MOONEY AIRCRAFT, INC.

SERVICE LETTER 20-53

DATE: NOVEMBER 16, 1959  
SUBJECT: INSPECTION OF BATTERY CABLES AND MODIFICATION OF BATTERY BOX  
MODELS AFFECTED: M-20 - M-20A Serial Nos. 1002-1453  
TIME OF COMPLIANCE: NEXT TIME SIDE COWL IS REMOVED

Figure No. 1

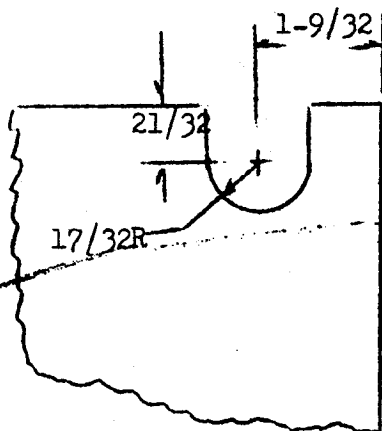
1. Remove left hand side cowl.
2. Remove battery box cover and disconnect the cables from battery poles.
3. Lift cables and grommets from battery box.
4. Inspect grommets and cables for cuts or wear. Replace or repair worn parts.
5. Figures 1 and 2 show a recommended rework for installations where battery cables are bearing too heavily against battery box.

INSTALL VINYL TUBING  
AND GROMMET AS SHOWN
